CITY PLAN COMMISSION STAFF REPORT

November 20, 2024

Project Name
Project Maartin

Request
CD-CPC-2024-00107
Development Plan – Nonresidential

1 Landscape Plan

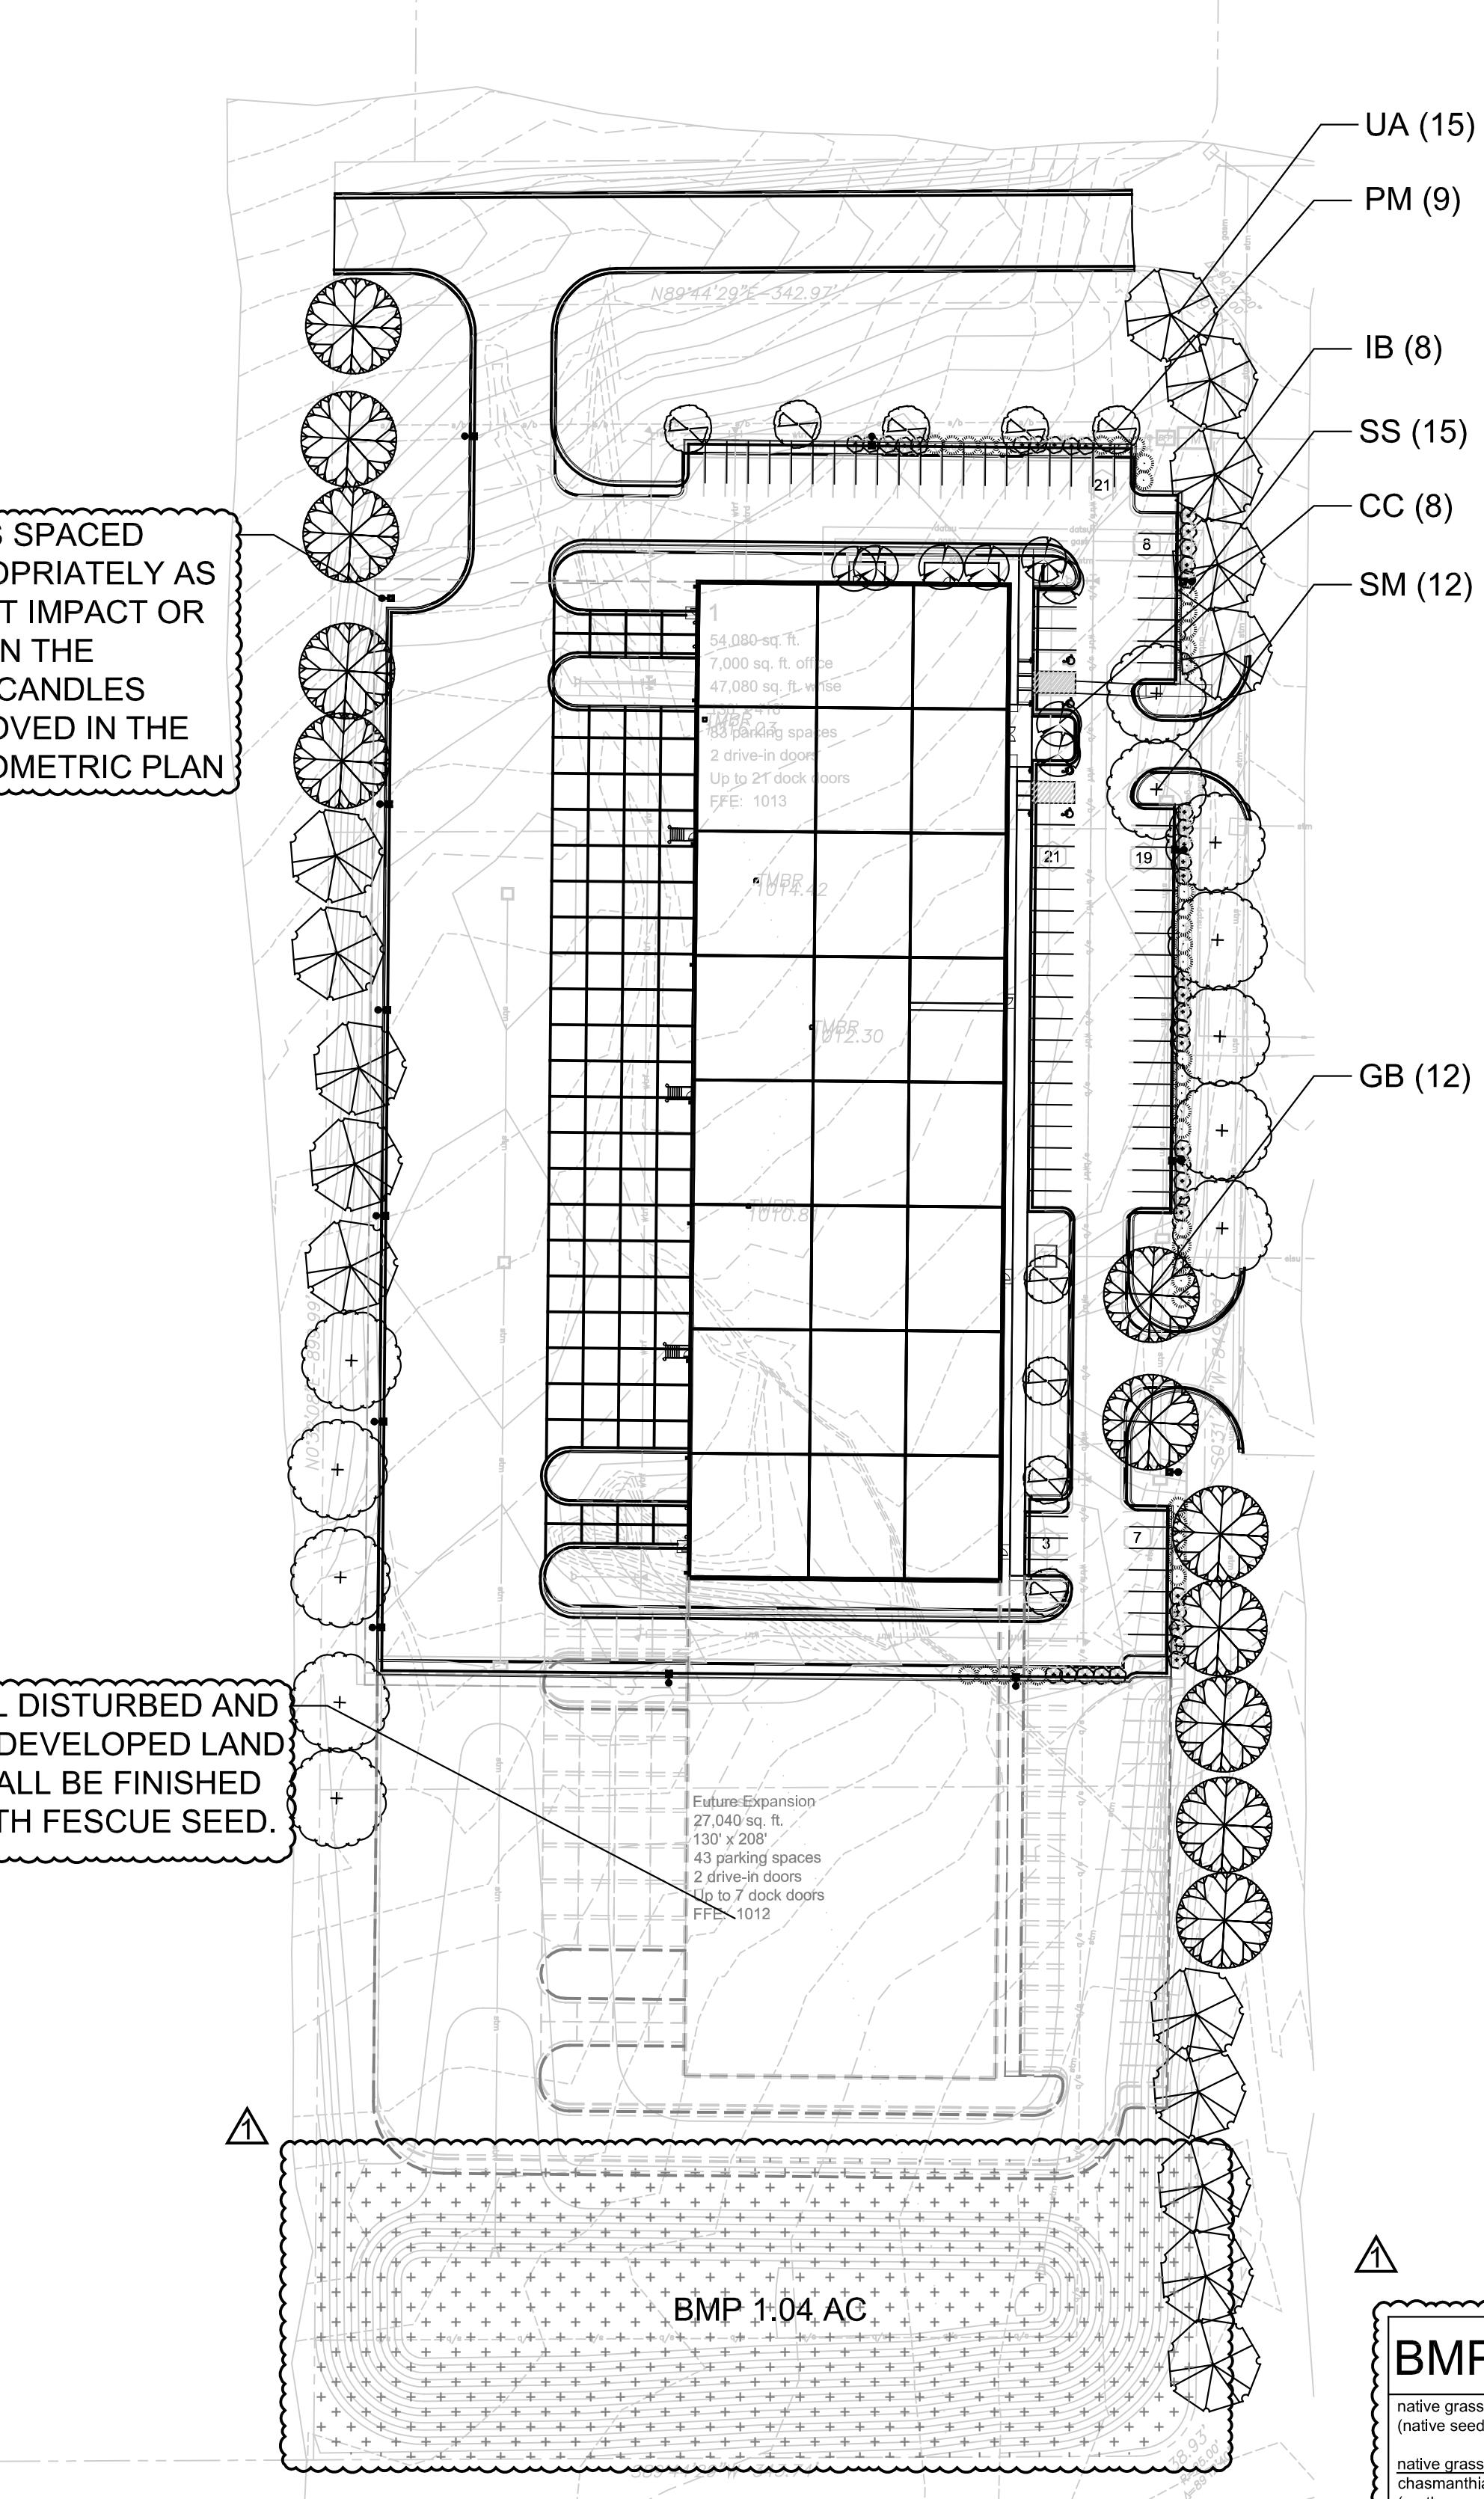
Street trees and other proposed landscaping will screen the parking areas visible from North Everton Avenue. Proposed species include Elm, Maple, Ginko, Redbud, Switchgrass, and Inkberry. The proposed development will remove 3.7 acres of existing tree canopy. The developer is planning to pay a fee in-lieu of planting.

G. Landscaping, berms, fences, and/or walls must be provided to buffer the site from undesirable views, noises, lighting, or other off-site negative influences and to buffer adjacent properties from negative influences that may be created by the plan.
Landscaping is provided on the plan in accordance with the Code. There will be adequate screening of the parking area from N Everton Avenue. The stormwater detention area will be seeded with a native seed mix.

2. That prior to issuance of the Certificate of Occupancy for each lot within the plat the developer shall submit an affidavit, completed by a landscape architect licensed in the State of Missouri, verifying that street trees have been installed in accordance with the approved Street Tree Planting Plan and are healthy.

5. The developer shall submit an affidavit, completed by a landscape architect licensed in the State of Missouri, verifying that all landscaping required of the approved plan has been installed in accordance with the plan and is healthy prior to Certificate of Occupancy.

1 | Tree Preservation and Protection Plan

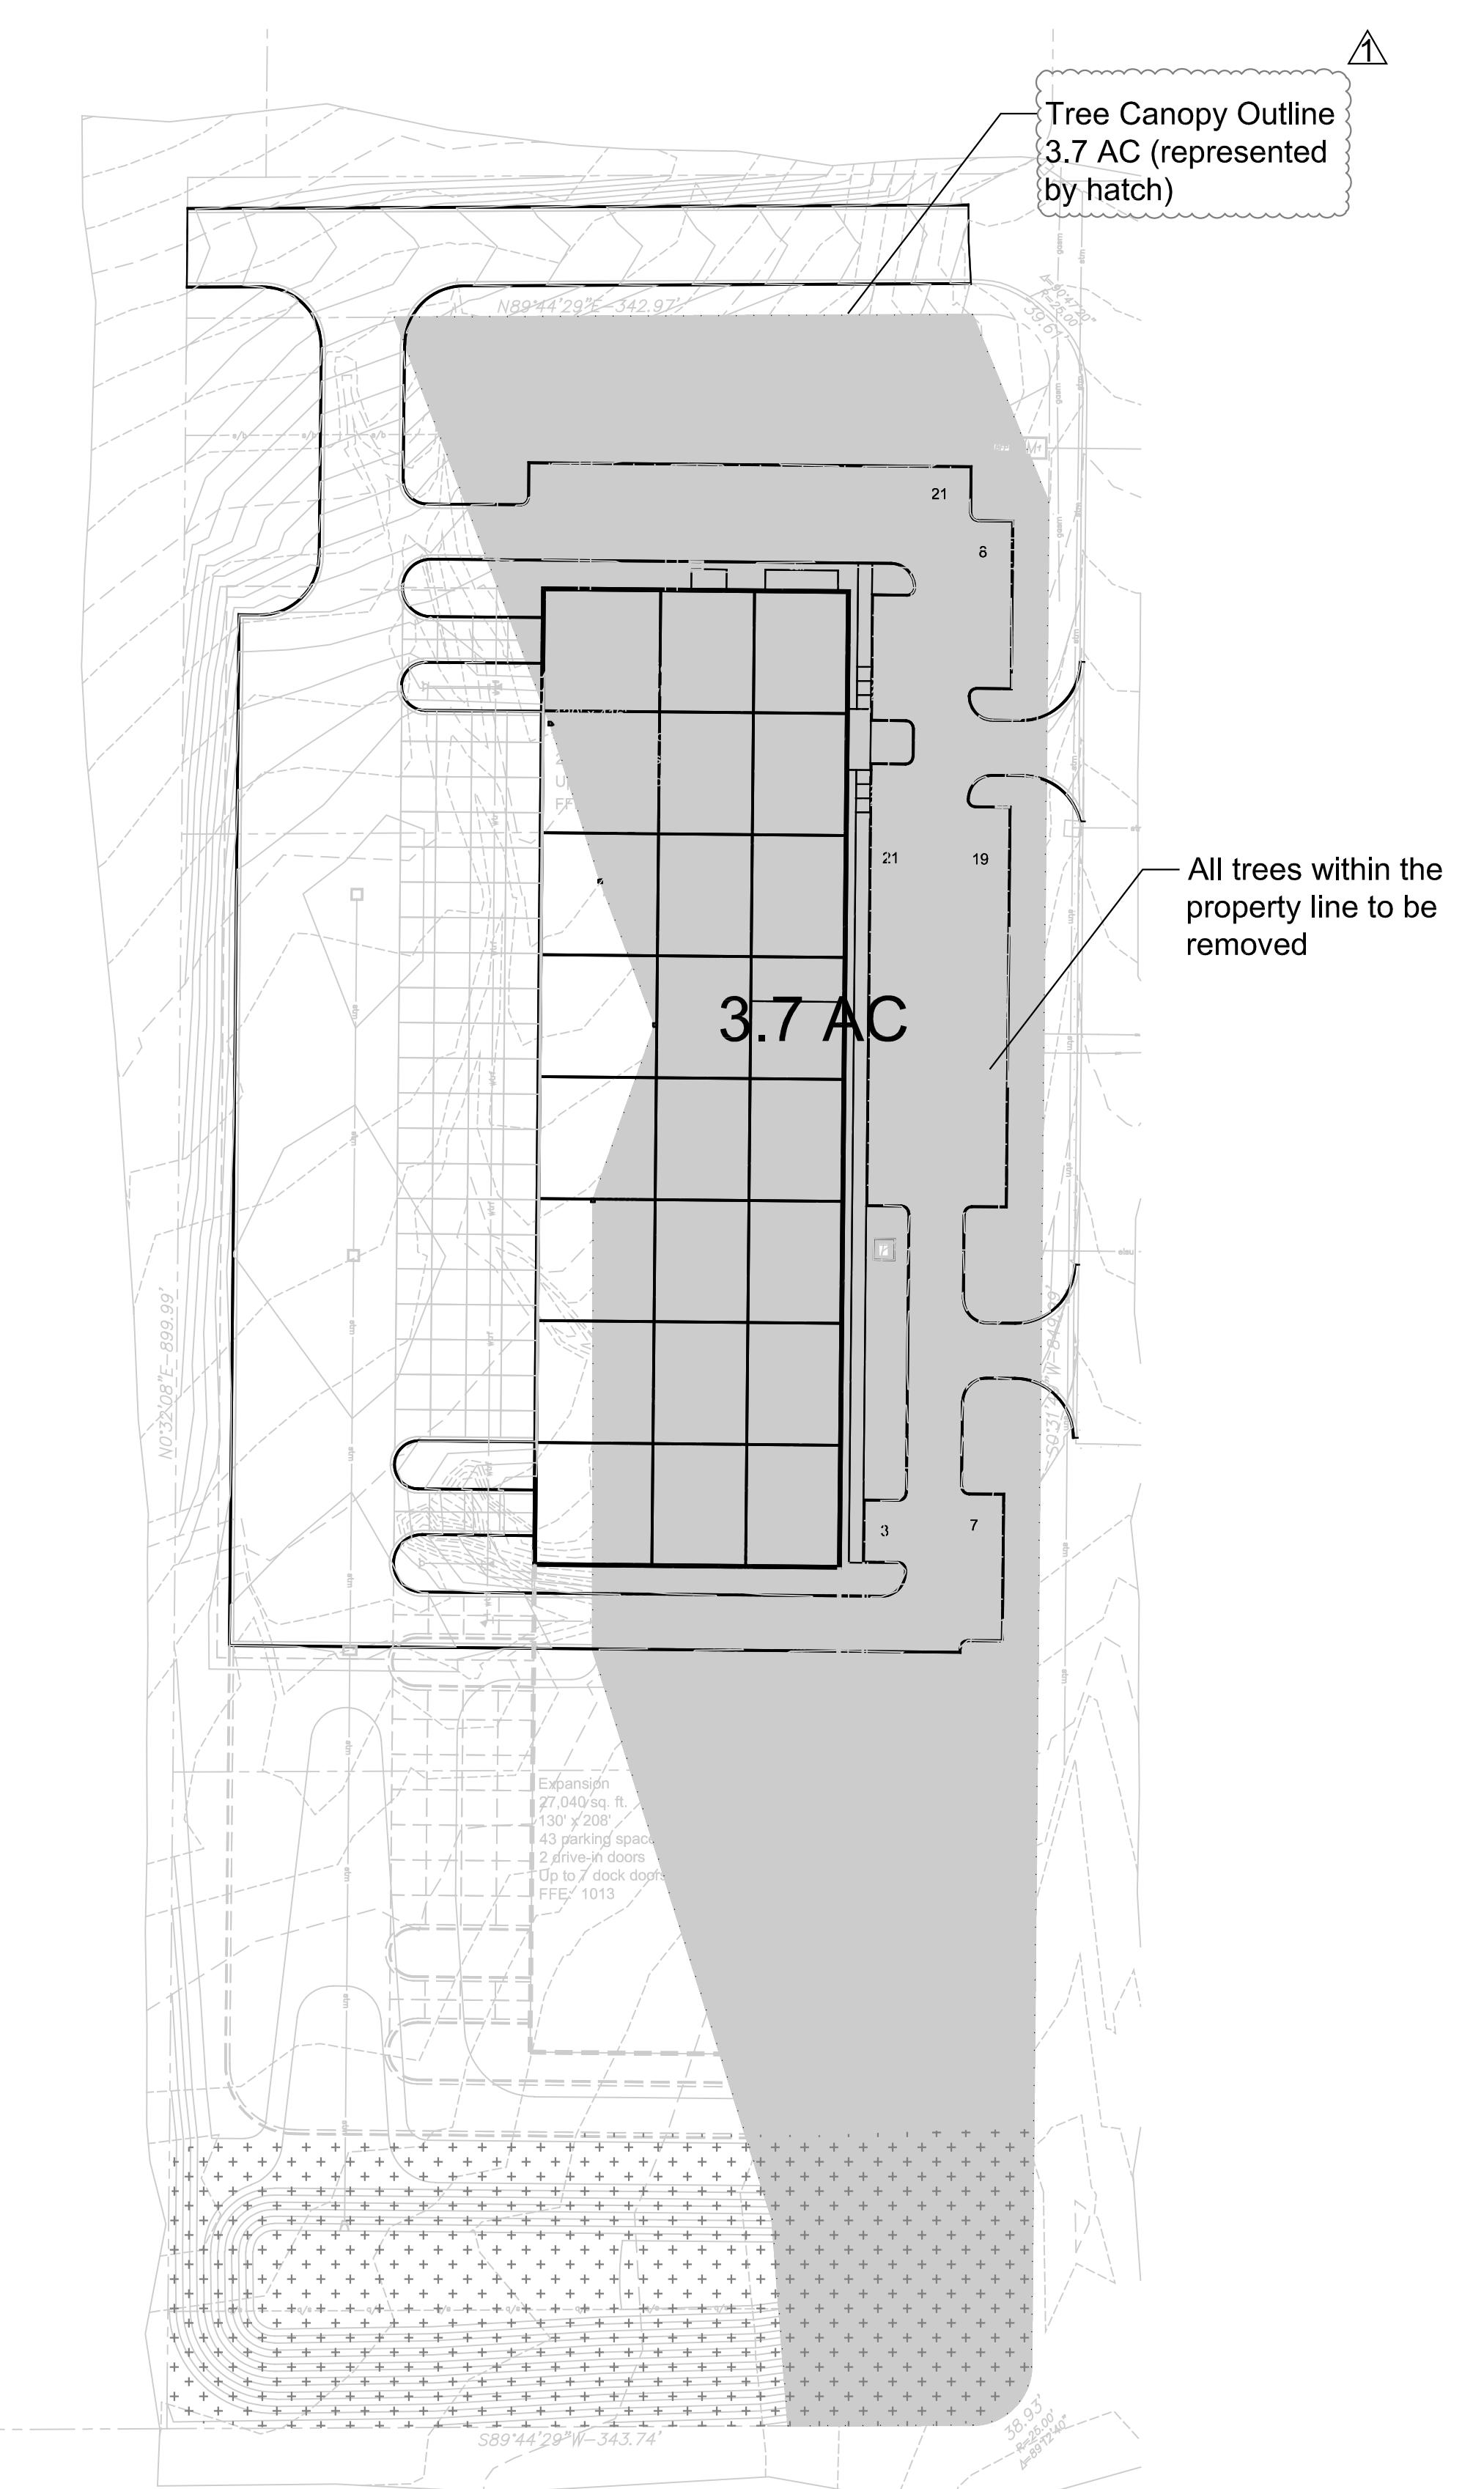
I. The plan must identify trees to be removed and trees to be preserved during the development of the subject property with the goal of saving trees that are not required to be removed for the development of the property.
A tree preservation and mitigation plan was submitted with this project. All tree canopy, 3.7 acres, will be removed. The applicant is opting to pay a fee in lieu of planting 82 caliper inches (41 trees), for a total of 15,170 dollars.

18. The developer shall be responsible for tree preservation in an easement or platted tract, mitigation planting, or payment of cash-in-lieu of preservation or mitigation planting, or any combination thereof in accordance with 88-424. Should the developer choose to pay cash-in-lieu of preservation or mitigation of all or a portion of the required area, the amount due shall be based upon the rate specified in 88-424. This requirement shall be satisfied prior to issuance of certificate of occupancy, or prior to the recording of the final plat, whichever occurs first.
